**Identification cards — Test methods —**

Part 1:  
**General characteristics**

**AMENDMENT 1**

### AMENDMENT 1

**Figure Amd.1-1 — ICC-holder**

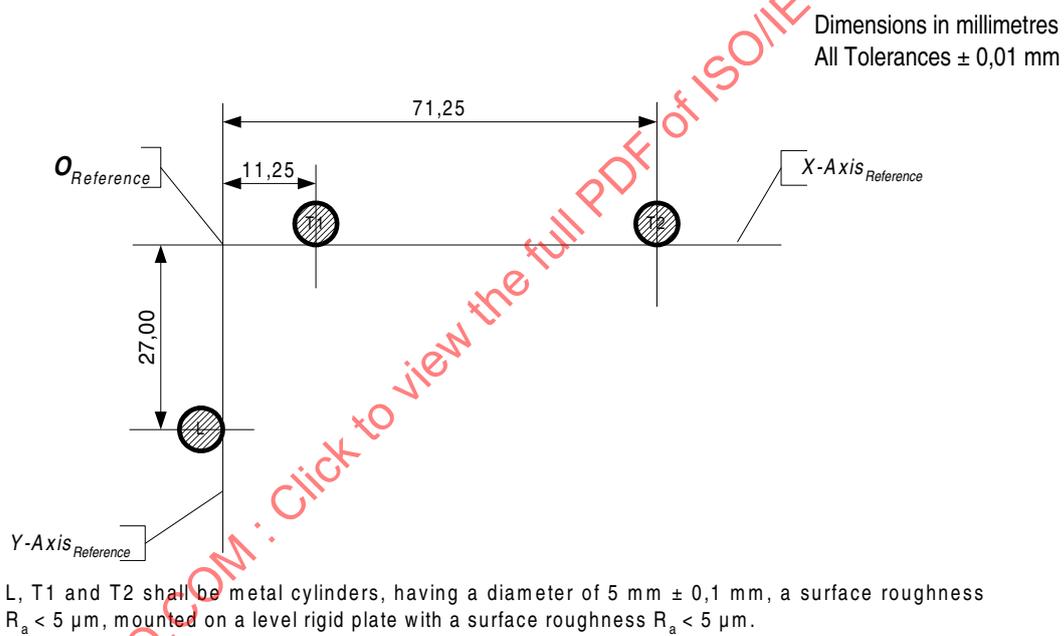
**4.7.2 Default ICC-holder and reference axes:**

The default ICC holder shall comply with Figure Amd.1-1:

Figure Amd.1-2 — Flattening plate

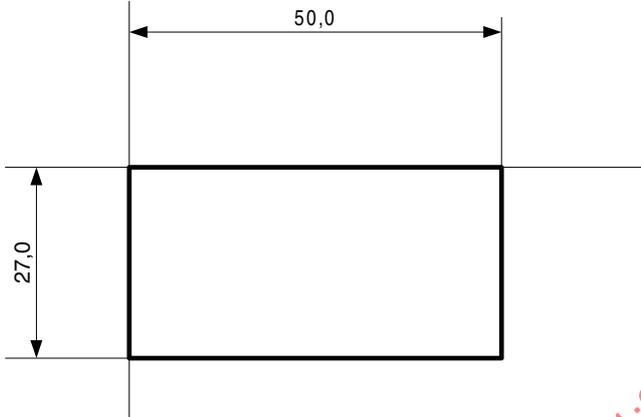
The flattening plate shall comply with Figure Amd.1-2:

Dimensions in mm  
All Tolerances  $\pm 0,1$  mm

The surface roughness of the flattening plate shall be  $R_a < 5 \mu\text{m}$ .

Figure Amd.1-3 — Position of ICC and flattening plate on ICC-holder

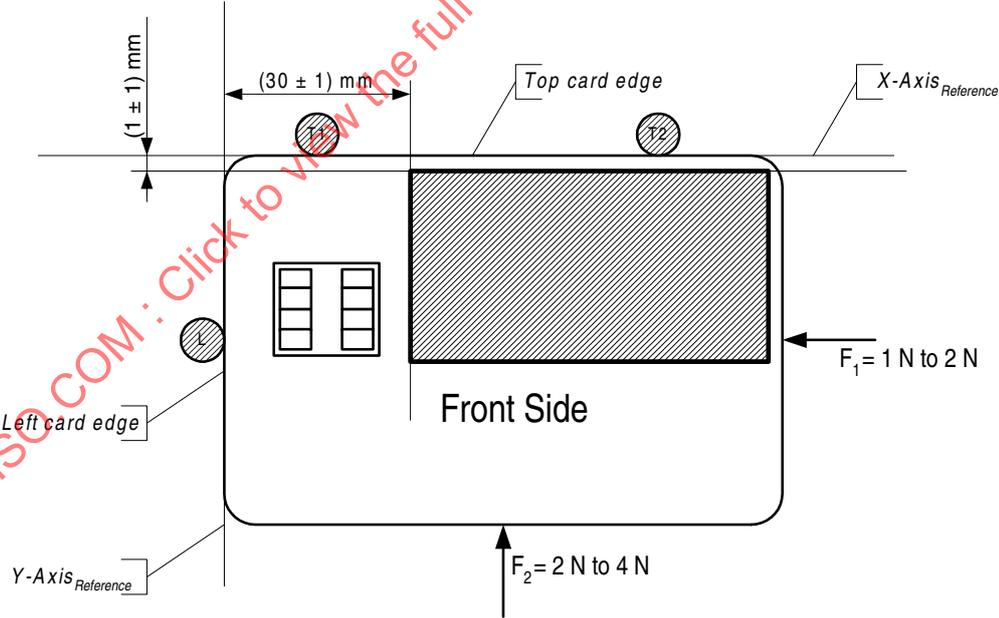
The ICC and the flattening plate shall be mounted on the ICC-holder as shown in Figure Amd.1-3:

$F_1$  and  $F_2$  are forces applied to the center of the right and the bottom edge of the card respectively to fix the card in the card-holder.  
The flattening plate shall apply a force of  $2,2 \text{ N} \pm 0,2 \text{ N}$  to the surface of the card

Figure Amd.1-4 — ESD test circuit

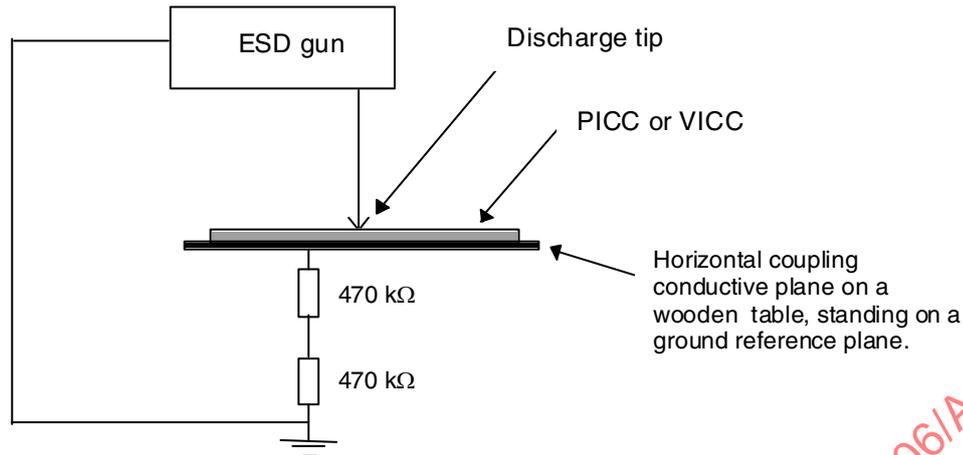
Connect the ground pin of the apparatus to the conductive plate upon which the PICC or VIVV is placed (see Figure Amd.1-4).

Figure Amd.1-5 — Test zones on PICC or VICC for ESD test

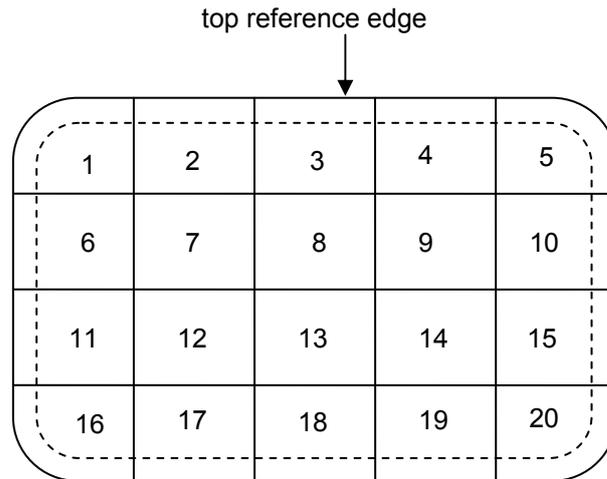
Apply the discharge successively in normal polarity to each of the 20 test zones shown in Figure Amd.1-5 ensuring that the discharge tip is not applied within 6 mm of the card perimeter (see the dashed boundary line in Figure Amd.1-5) and allowing a cool-down period between successive pulses of at least 10 s.

**WARNING — If the PICC or VICC includes contacts, the contacts shall face up and the zone which includes contacts shall not be exposed to this discharge.**

Figure Amd.1-6 — Test prods

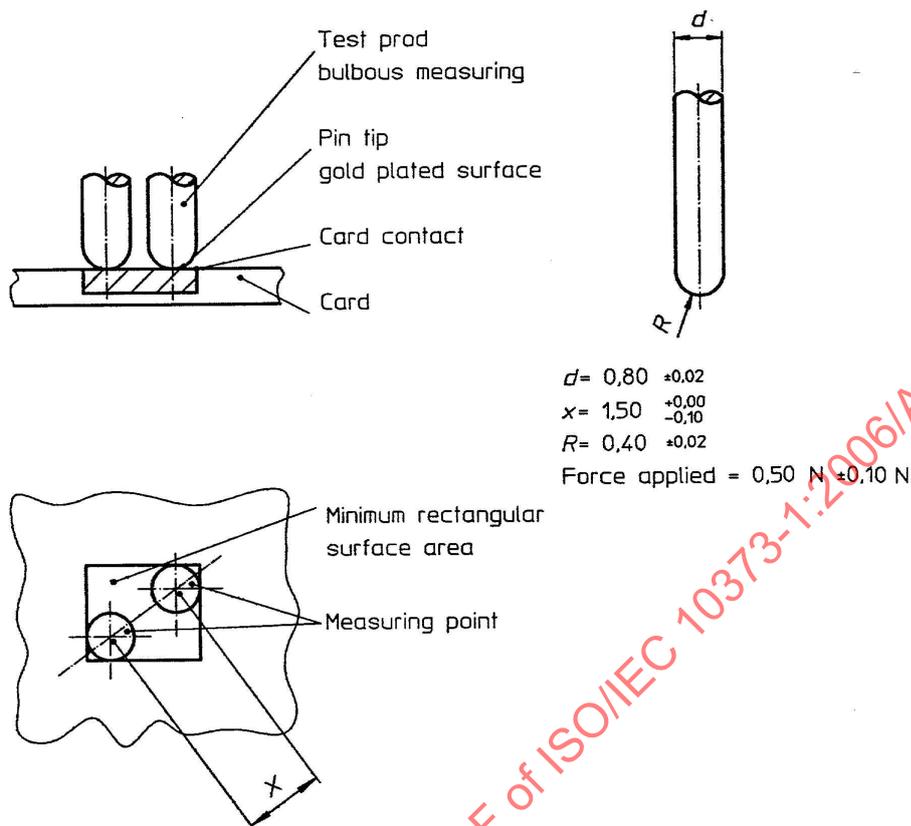
Ohmmeter with a range from 10 mΩ to 2 Ω having an accuracy of ± 2 mΩ and test prods as defined in Figure Amd.1-6. The measurement current shall be less than or equal to 100 mA and the measurement voltage shall be less than or equal to 20 mV.

Figure Amd.1-7 — Measurement tip

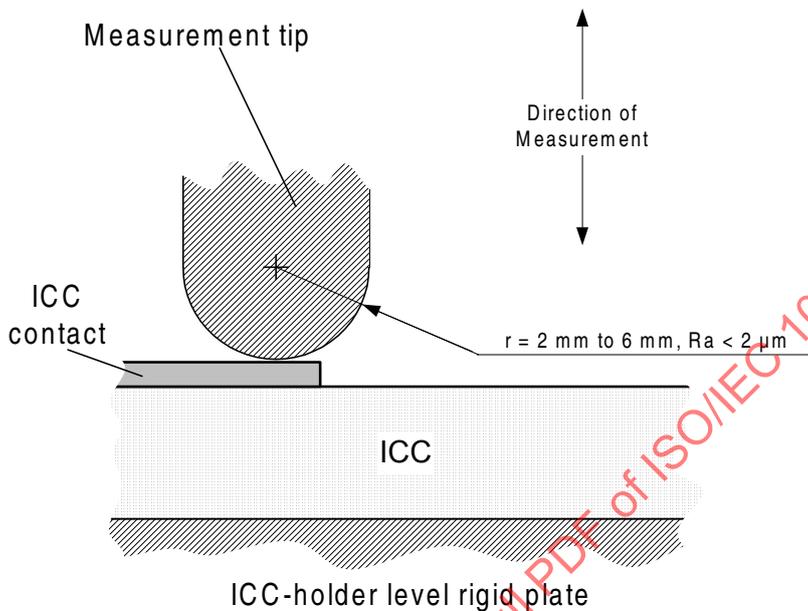
A measurement device capable of measuring the perpendicular distance between the upper surface of the level rigid plate of the ICC-holder and the upper surface of an ICC placed on the ICC-holder with an accuracy of 0,01 mm. The area of measurement shall be 2,5 mm wider in all directions than the area covered by the contact metallization of the ICC to be tested. The measurement tip shall be as shown in Figure Amd.1-7:

Figure Amd.1-8 — Measurement line across contacts C1 and C5

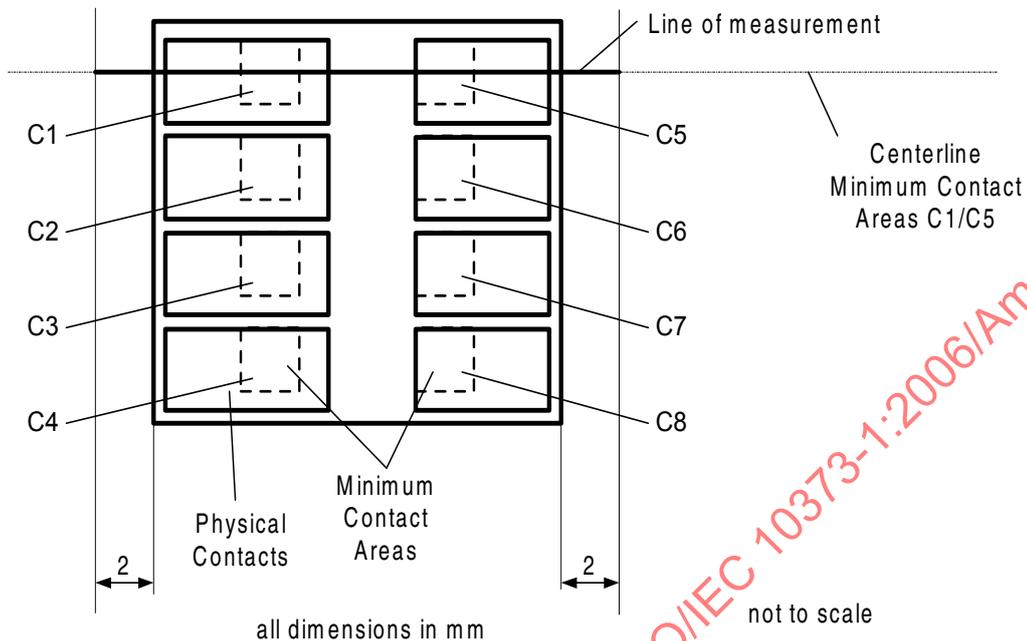
- Mount the ICC in the default measurement position as defined in 4.6.1.
- Construct a measurement line on the surface of the ICC along the centerline of the minimum contact areas C1 and C5, beginning and ending at a distance of 2 mm of the metallized contact surface (Figure Amd.1-8).

Figure Amd.1-9 — 3 wheel test principle

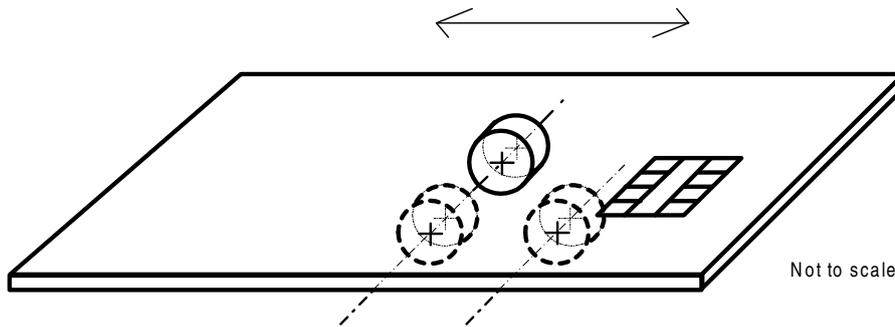
The principle of the apparatus is shown in Figure Amd.1-9. It comprises three wheels, one above and two below the ICC. The ICC is moved cyclically between the three wheels, so that the contact area is repeatedly exposed to the forces exerted by the wheels.
